**STAFF REPORT: FEBRUARY 12, 2025 MEETING**

**APPLICATION NUMBER: HDC2025-00009 // VIOLATION NUMBER: 21-410**

**ADDRESS: 3470 CAMBRIDGE**

**SCOPE: REPLACE STEEL WINDOWS WITH VINYL-CLAD WOOD WINDOWS, REPLACE RAILINGS AND DOORS (WORK COMPLETED WITHOUT APPROVAL)**

*Above: Façade. Google street view, August 2015.*

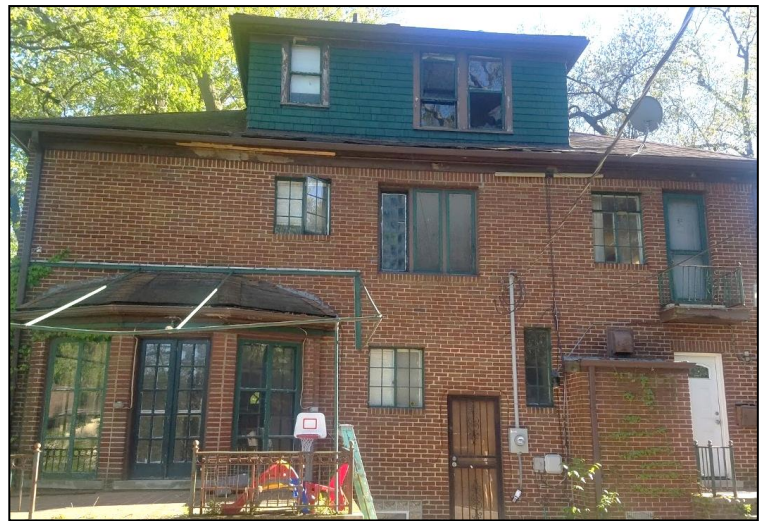
- The historic windows were replaced with Anderson 400 Series vinyl-clad wood windows. The majority of openings now have double-hung one-over-one windows; however, the larger openings on the front, west side, and rear have sliding units. The front sliders have between-the-glass grilles. Sliding windows and between-the-glass grilles are not consistent with the general characteristics of a historic window of the type and period of this house and are not compatible with the overall historic character of the dwelling.
- The placement of the new windows doesn't match the more deeply recessed location of the historic windows within the window openings. The depth of plane change between window and wall surfaces is an important feature on the elevations of the house and the current windows don't convey the same visual appearance.

*The depth of the "before" steel windows is quite evident and clearly offers a relief from the masonry wall. The replacement windows are minimally set back in the window opening, and from a distance, appear to be in plane and a part of the exterior wall.*

- Additionally, the removal of the historic windows without a thorough examination of their repairability, coupled with the installation of replacement windows constructed of a different material, operation and pattern, does not meet the following Secretary of the Interior Standards:

- The windows were removed without HDC approval; the scope of work that would meet the requirements of the historic ordinance (Section 21-2-59(e)) is the fabrication and installation of new steel-framed windows with an identical pattern and operation as the historic windows, and wood one-over-one double-hung sash at the third floor, with dimensions that match the historic windows.

*The rake board in the designation photo is flat and has a sheen. This indicates the rake boards were covered with aluminum.*

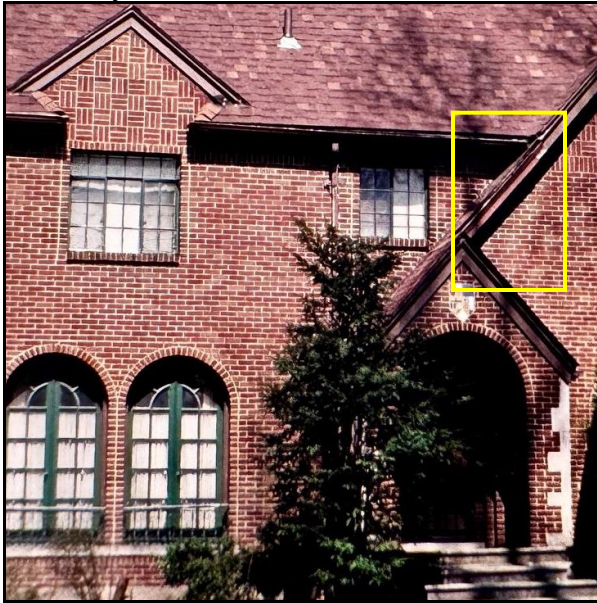
- With this application, staff offers additional analysis: Staff noted the designation photo appears to show the rake boards, soffit and fascia on the façade of the house covered with aluminum. While this may have been an existing condition at time of designation, when a non-historic product is removed or proposed for replacement, the Commission regularly does not approve the reinstallation of non-historic materials to cover intact and repairable original features and materials. Therefore, the recently installed aluminum can be removed, and the wood rake boards, fascia and soffits be repaired as needed.

- The applicant’s photos of the west side gable wall and front entry gable show the profiles of these wood rake boards are highly dimensional. The rake board of the largest gable on the façade appears to have been repaired, and the hole in the soffit could be repaired and these components painted. Painted wood surfaces offer a mostly matte finish, in keeping with the brick wall surface. Aluminum coil only offers mostly flat, minimally bent and shiny/reflective surface.

- The Commission regularly does not approve the reinstallation of non-historic materials to cover intact and repairable original features and materials. Therefore, the recently installed aluminum should be removed, and the wood rake boards, fascia and soffits be repaired and painted as needed.

*This undated applicant photo shows an intact highly profiled rake board on the west-facing gable wall. Note the curved edge at the bottom right of the photo. This detail common on English Revival houses may have been removed upon covering the rake board with aluminum.*

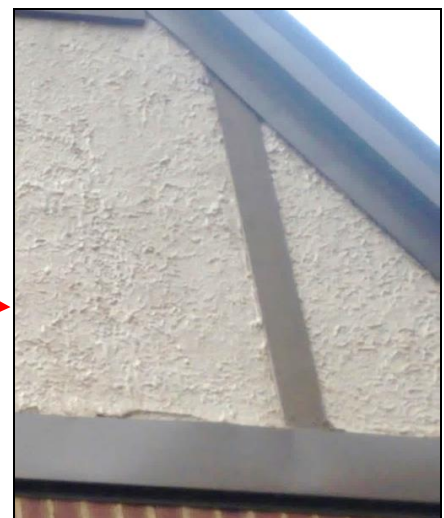
*This close-up photo shows the current condition of the identified area of the photo at left.*

*Above left: One set of railings that closed one set of French doors.  
 Above right: Rear of house that shows the original railings in place at the raised patio, Juliet balcony and rear door.*

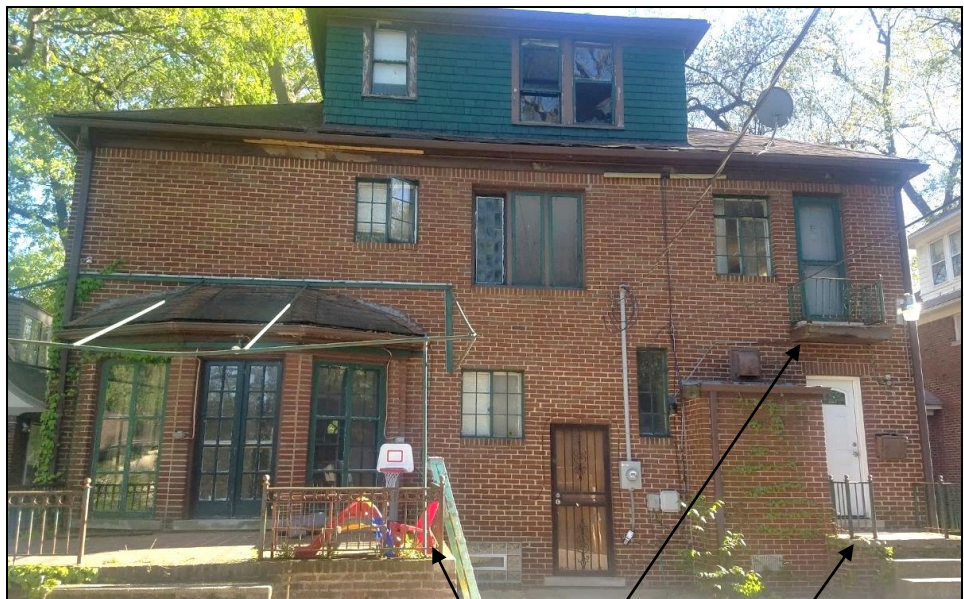
- With this application, staff offers additional analysis: The railings on the front and rear of the house and the Juliette balcony were distinctive character-defining features. The visual delicacy and intricate designs of the railings and balcony were sculptural elements and integral to the architectural design of the house.

- The limited photographic documentation showed some corrosion on the rear patio railing and one set of French doors railing, but again, no repair estimate was submitted to confirm its level of deterioration (i.e., was it just surface corrosion?) and possibility of repair. The railings were intact and appeared to be repairable. No repair estimates were submitted with the 2020 application to show that they were beyond repair.

- The Juliette balcony on the rear wall was a unique feature of the house. The Sherwood Forest Elements of Design calls out the balconet (which staff has identified as a Juliette balcony):

- The newly built large open porch and tall aluminum railings erected at the two porches and raised patio do not match the removed historic features, nor is the new work compatible with the massing, scale, physical features and workmanship of the historic property.
- The removal and/or replacement of the historic components do not meet the Secretary of the Interior Standards 2, 5, 6 and 9 (listed on page 8).

- As the railings and balcony were removed without HDC approval, the scope of work that would meet the requirements of the historic ordinance (Section 21-2-59(e)), are the fabrication and installation of new iron railings and Juliette balcony to match the materiality, design, dimensions and finish colors as the historic elements that were removed.

Staff photo from sidewalk, January 24, 2025.  
It appears that the black fencing was installed at the property line and a section of new chain link fencing was installed to bridge the space between the new black fence and an existing chain link fence.

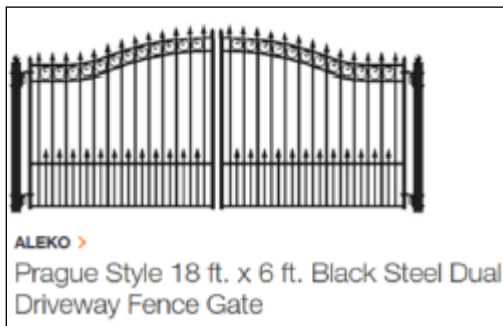
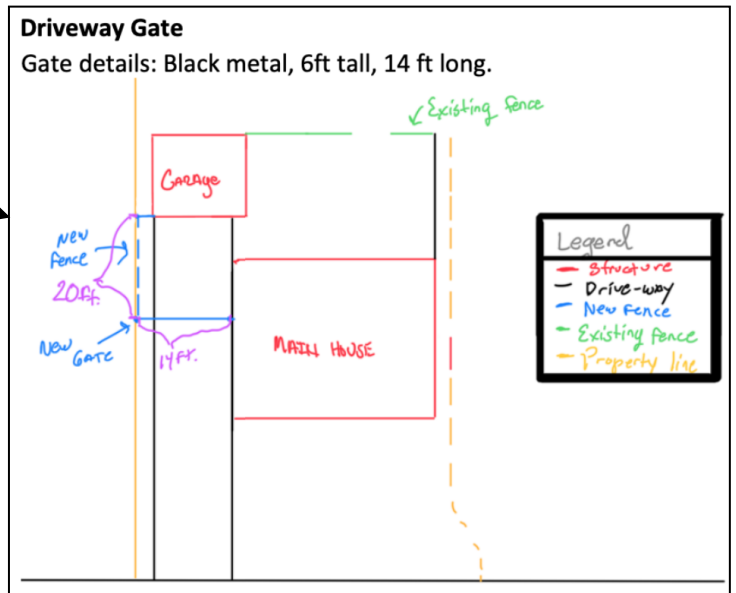
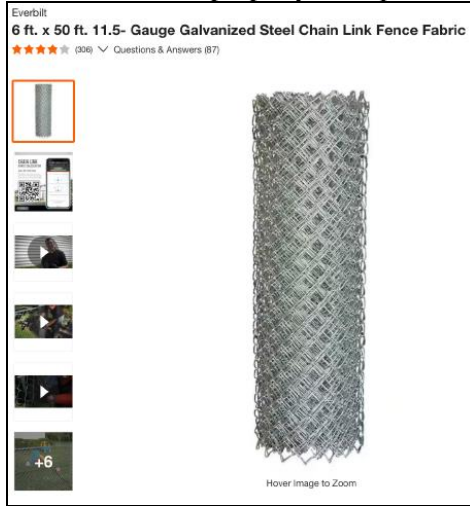
- The 2020 application included a cut-sheet for the driveway gate (identical to the one shown below). This gate was approved by the Commission. The COA also specified that a 6’-0” black fence would be installed from the gate to the front corner of the garage, as outlined in the map. The gate and a section of black fence have been installed.
- The current application requests that a section of 6’-0” chain link fencing also be installed at the west side property line, to bridge the space between the black fence and an existing chain link fence. Chain link fencing is allowable at side property lines per the Commission’s *Fence and Hedge Guidelines*.
